WELL NAME Southwest Salt Company #2 - Roach-Baker (Strat)

Plugging Plan for Roach-Baker #2
Revised by Morton Salt
January 16, 1990

RE: Southwest Salt Roach Baker #2
Plugging and Abandonment Plan

Plugging Plan Revised by US EPA Region 9
Morton Salt - Roach Baker #2

Plugging Plan
Morton Salt - Roach-Baker #2 (548)

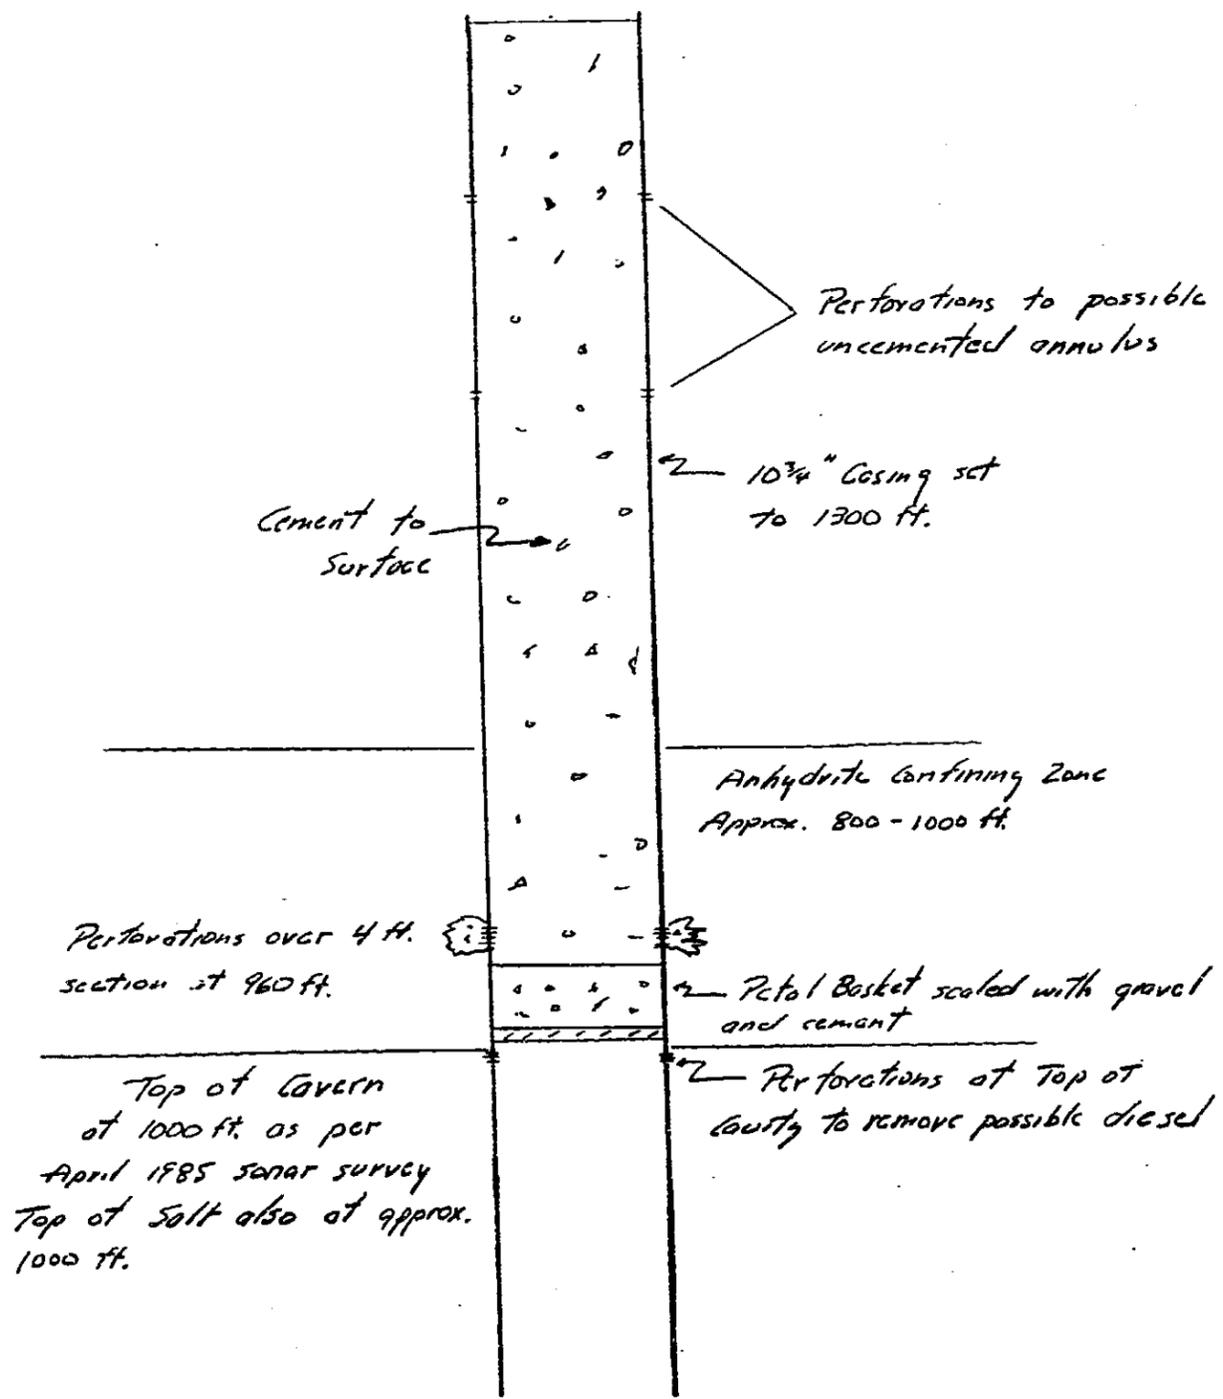
Wait how long?
